Product change note

Topic **Firmware and hardware update for EVK-M8L, EVK-M8U, C93-M8E**
Author **Martin Wallebohr**
Date **6 August 2020**

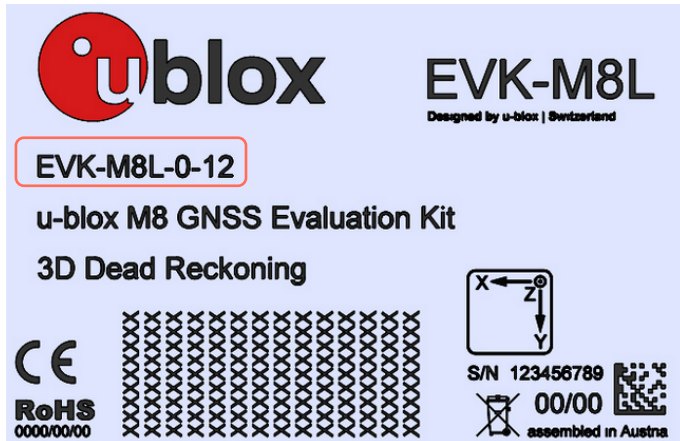
Updated products can be identified by a type number on the label which is marked in red on the figure below. Please note that an updated C93-M8E cannot be identified by label but only by reading out firmware version via UBX-MON-VER [6].
